CITY OF ALBUQUERQUE

Re: Palomas Peak
8310 Palomas Ave 87109
Traffic Circulation Layout
Engineer's/Architect's Stamp 11-01-2019 (D19D031)

Based upon the information provided in your submittal received 01-09-2020, the above referenced plan cannot be approved for Building Permit until the following comments are addressed:

Figure 3.8-2 Parallel Parking Dimensions

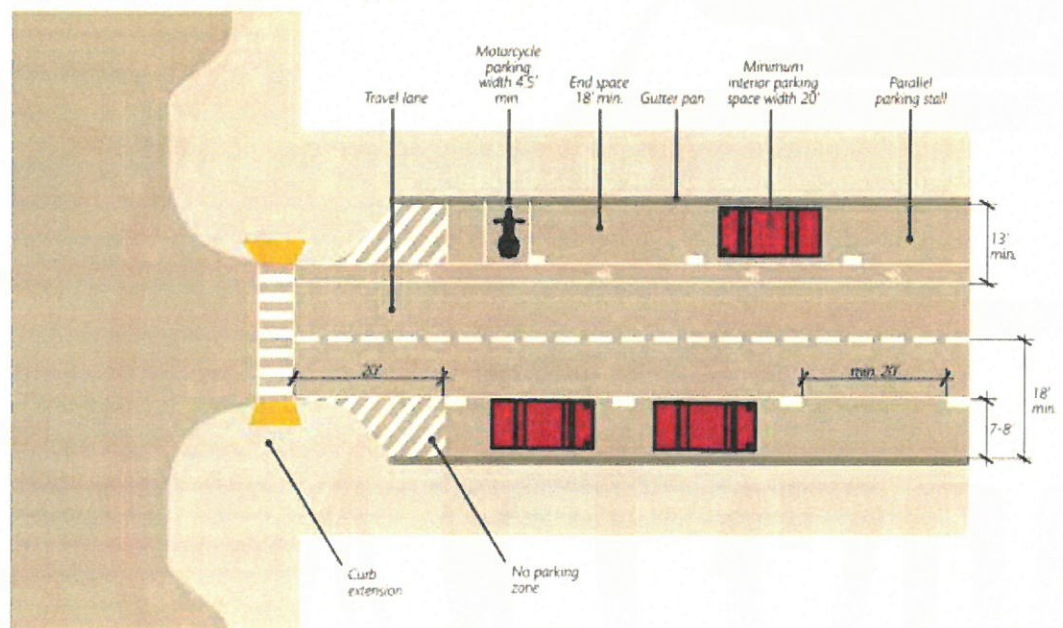
1. I am attaching the on-street requirements in terms of dimension.
2. Please list the width and length for all proposed parking spaces. Some dimensions are not shown.

2. The gutter pan may be used as part of the stall width.
3. Where parallel on-street parking is adjacent to a bicycle lane (and there is insufficient space for reverse angle parking), the minimum combined width for the bike lane and the parallel parking stall is 13' (with a recommended 7'-wide parallel parking stall and a 6'-wide bike lane).

4. The combined width of a parallel on-street parking stall and the adjacent travel lane should be a minimum of 18'.
5. A 1.5' shy zone space or offset shall be provided between the curb edge and any vertical elements in the landscape/buffer zone.

6. Individual stalls may be marked to increase the parking capacity. The minimum stall length for interior spaces shall be 20', and all end spaces shall be a minimum 18' long. See Figure 3.8-2.

7. Per MUTCD, there shall be a 20' long space between the crosswalk or pedestrian crossing and the nearest on-street parking space. A curb extension may be used within that 20' area.
